VALE OF WHITE HORSE LOCAL PLAN PART 2 EXAMINATION

REPRESENTATIONS ON THE SLC RAIL REPORT

This submission is made on behalf David Wilson Homes (Southern) (hereafter referred to as DWS) in response to the VoWH LPP2 Inspector's invitation to comment on document HEAR06.3 paper which was prepared by SLC Rail in relation to land to be safeguarded for the reopening of Grove railway station.

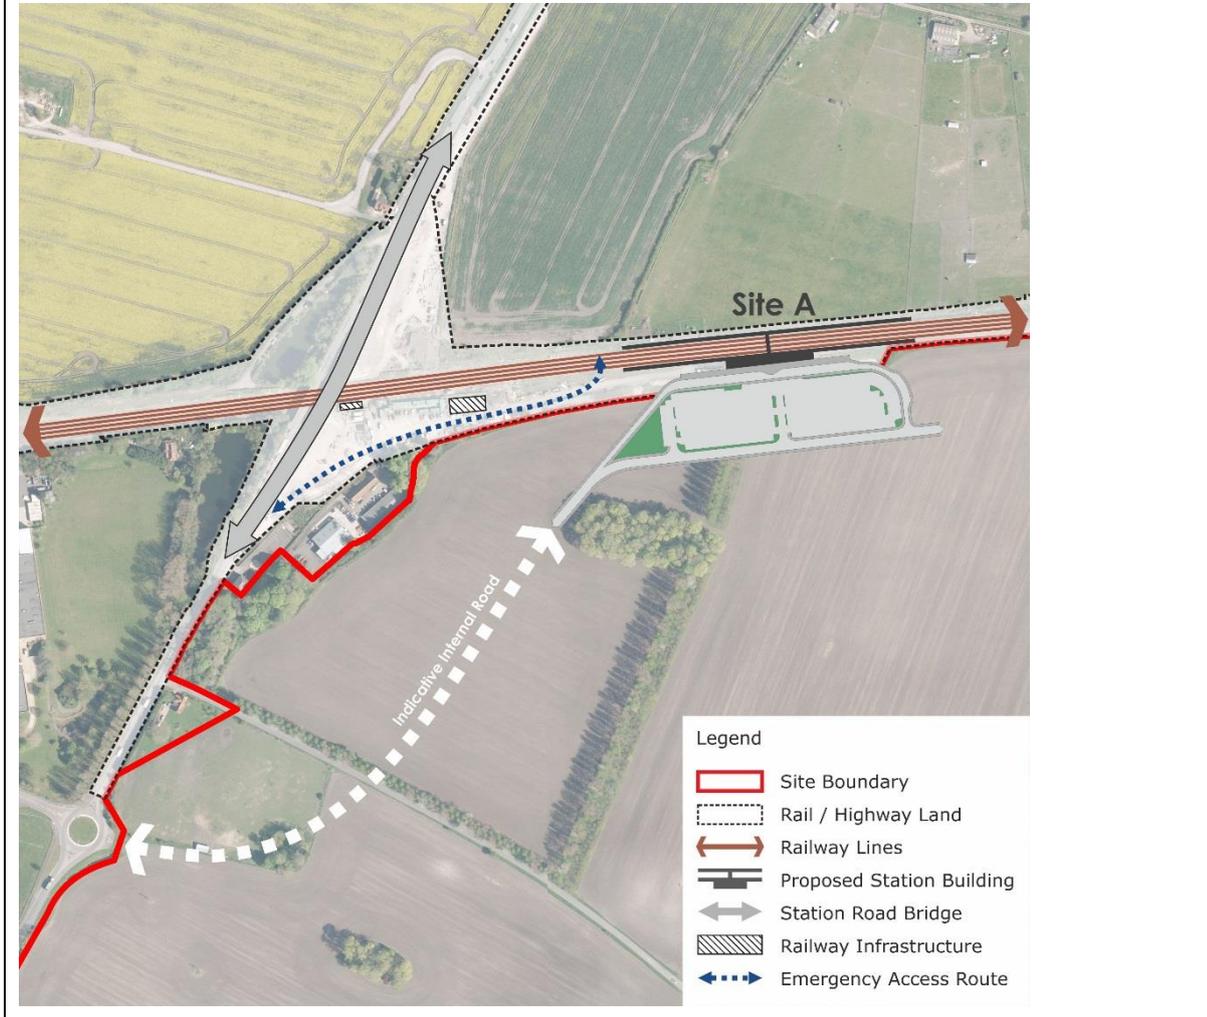
Having regard to the above, it is considered that the overall score for the Tulwick Park site should be increased from 9 to 13 making it the site with the highest score using the SLC Rail methodology even before adjustments are made to the 'Connectivity' and 'Land Use and Planning' scores awarded to the Bradfield and Denchworth Road sites. A 'Tulwick Park' Site Pro-Forma, which draws upon that prepared for the Grove Park (South) site, is accordingly provided below as follows:

For these reasons, it is clear that the VoWH were correct to safeguard land to the east of the A338, and should therefore be re-instated in general accordance with the following sketch.

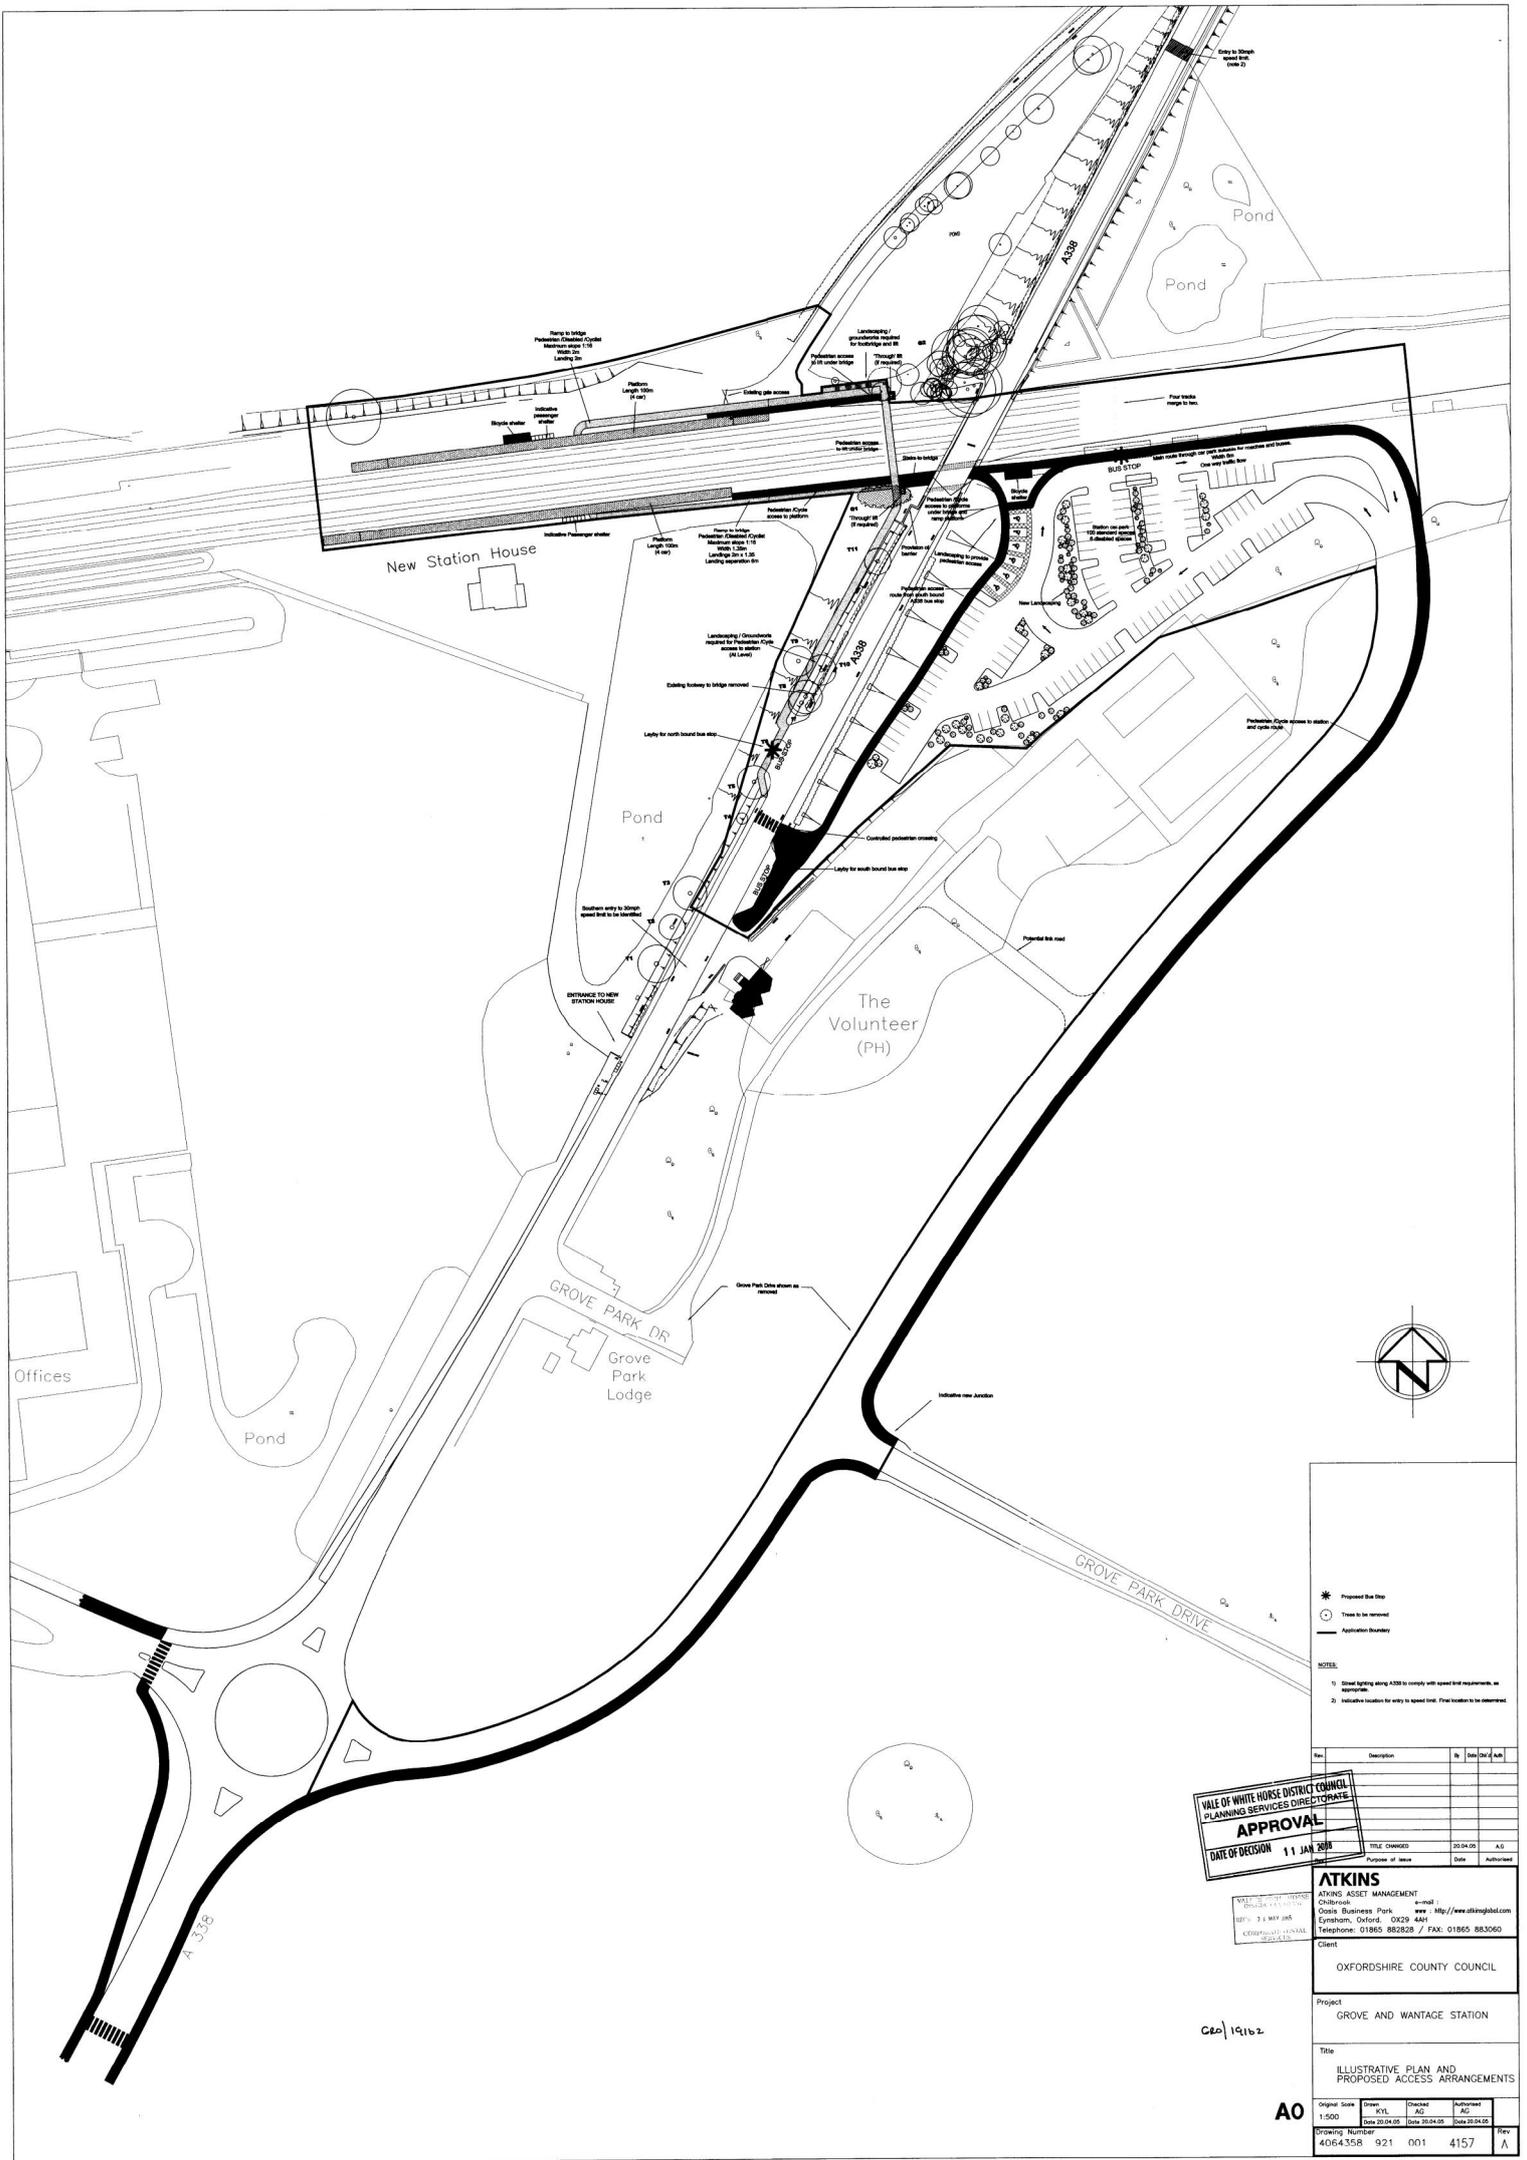
DWS therefore strongly recommends that the safeguarded land plan is amended to include the land shown on the following plan, which also shows the land previously identified to the east of the A338 by the VoWH for context:
